January 16, 2009

Docket No. 52-021
MHI Ref: UAP-HF-09002

Subject: MHI's Partial Responses to the NRC's Requests for Additional Information on Topical Report MUAP-07013-P (R0) "Small Break LOCA Methodology for US-APWR"

Figure RAI-8.1.3-8.1 Heat Transfer and Hydraulic Flow Regimes for Bottom Reflood (Ref.2)

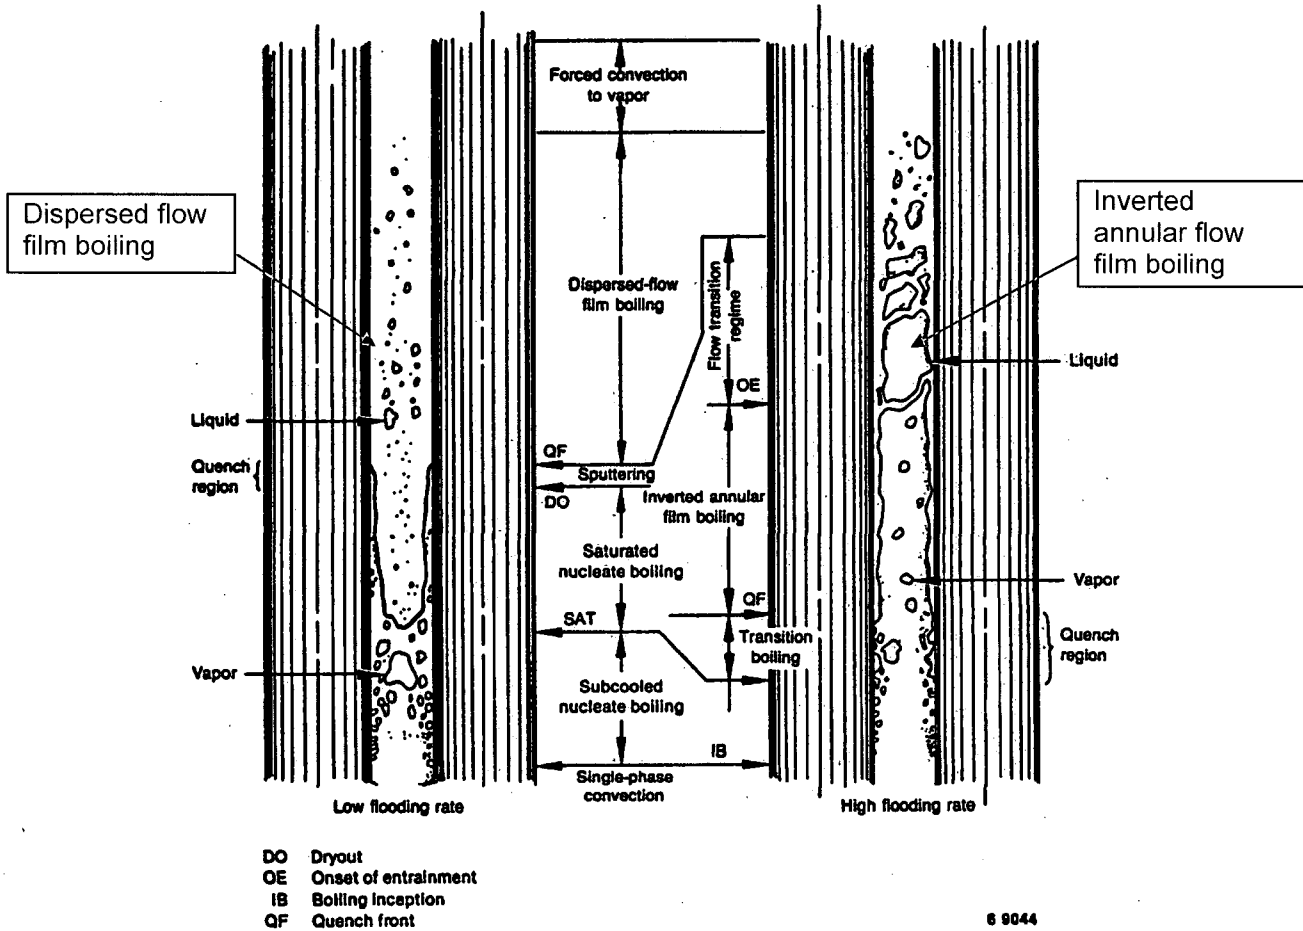
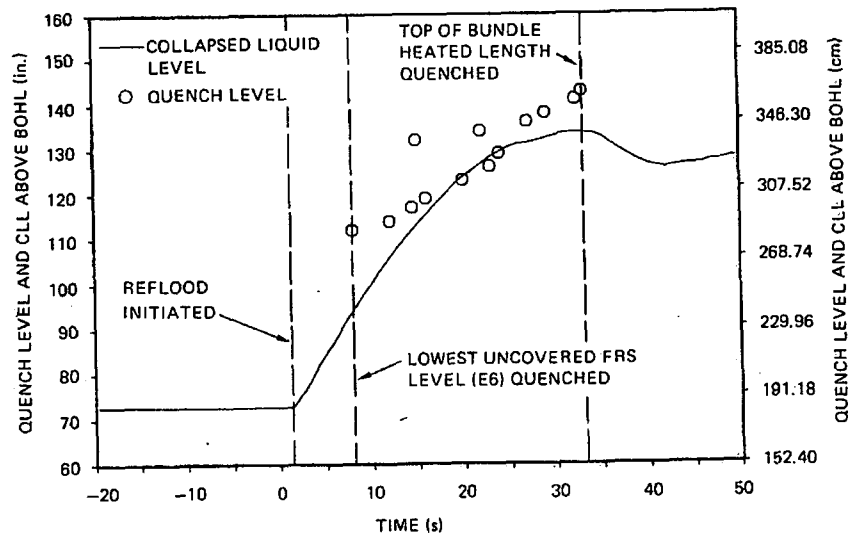
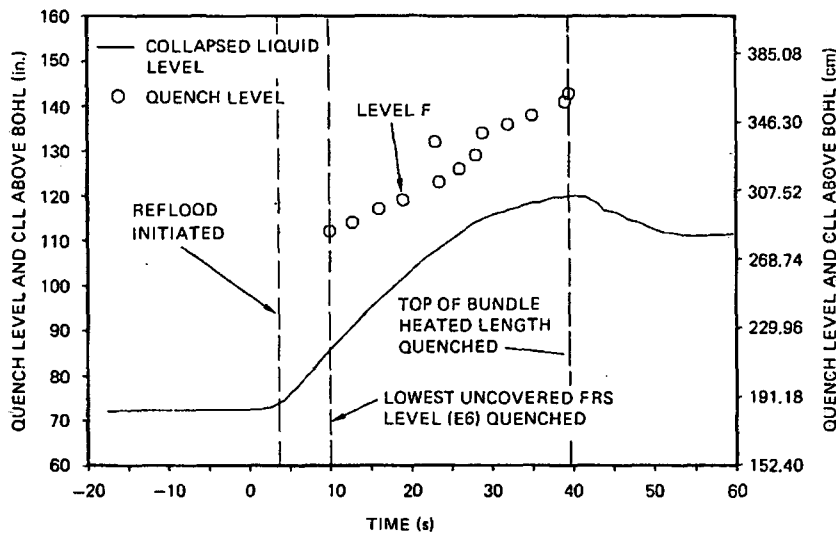
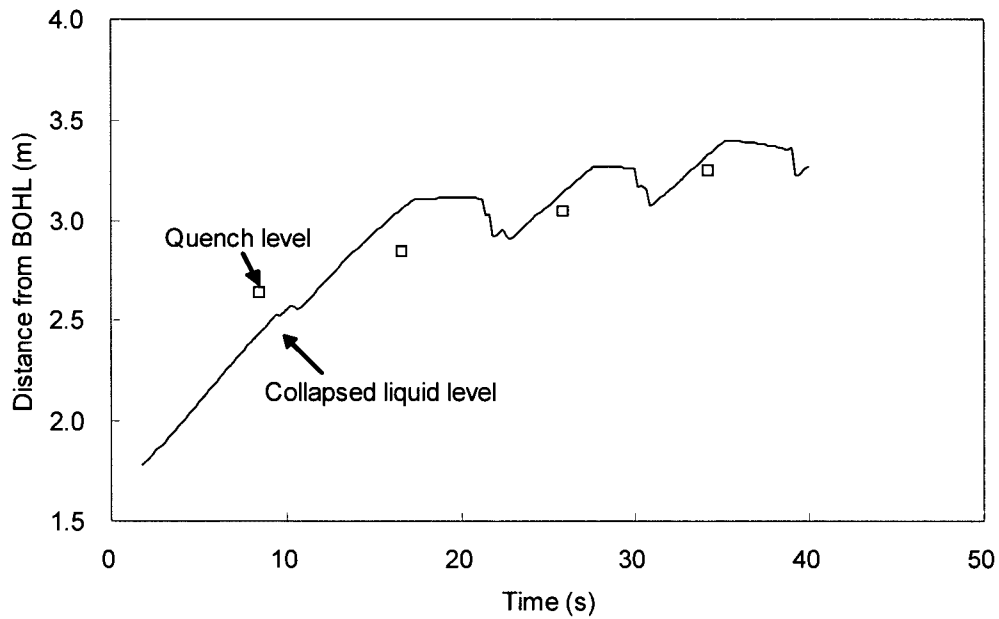
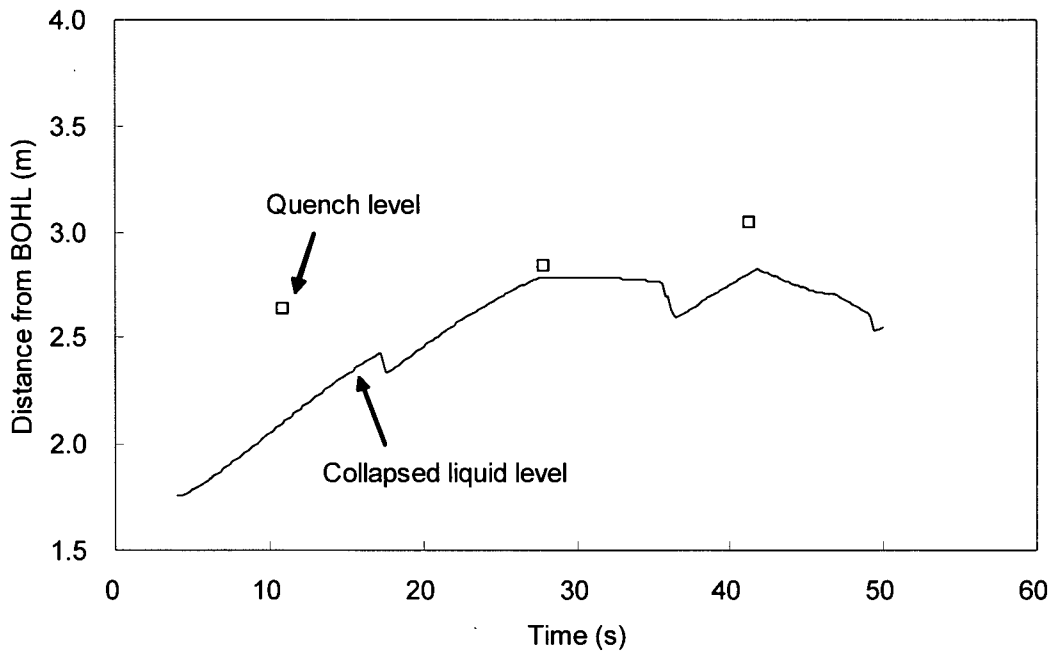
The quench velocities for test P (Figure 8.1.3-11) and test Q (Figure 8.1.3.15) are similar for the tests (about 3 cm/sec for P and 2.8 cm/sec for Q), but they are substantially different for the simulations (about 2.4 for P and 1.3 for Q). This may imply that the quench velocities for the simulation could be higher than the test for some parameter ranges, and thus the simulation may not be conservative. Please explain.

When the quench level is significantly above the collapsed liquid level, dispersed flow film boiling is suggested, while the inverted annular film boiling may be suggested when the quench level is near or below the collapsed level. These heat transfer and hydraulic flow regimes are schematically compared in Figure RAI-8.1.3-8.1 (Ref.2). Next, Figures RAI-8.1.3-8.2 and 3 show comparisons between the measured quench level and collapsed level histories for Tests P and Q, respectively, indicating that the dispersed flow film boiling possibly appeared in Test Q rather than Test P. Under the dispersed flow film boiling like Test Q, numerous droplets occur from the liquid level front, which effectively contribute to the precursor cooling above the liquid level before quench. This effectively decreases the vapor superheat and the fuel rod surface temperature in the uncovered-bundle region, and thus hastens the quench rate even though the flooding rate is low. This is why the difference in the measured quench rates between Tests P and Q was relatively small, in spite of the fact that the flooding rates were significantly different from each other.

Figures RAI-8.1.3-8.4 and 5 show comparisons between the collapsed and quench levels calculated by M-RELAP5 for Tests P and Q, respectively. The precursor cooling effect predicted by M-RELAP5 is significantly less than the measurement for Test Q. Figures RAI-8.1.3-8.6 and 7 show the axial distributions in terms of the applied heat transfer mode and computed heat transfer coefficient by M-RELAP5 for Tests P and Q, respectively. It is found that the dryout heat transfer coefficient just above the quench front in Test Q is reduced to [], due to the heat transfer mode different from Test P.
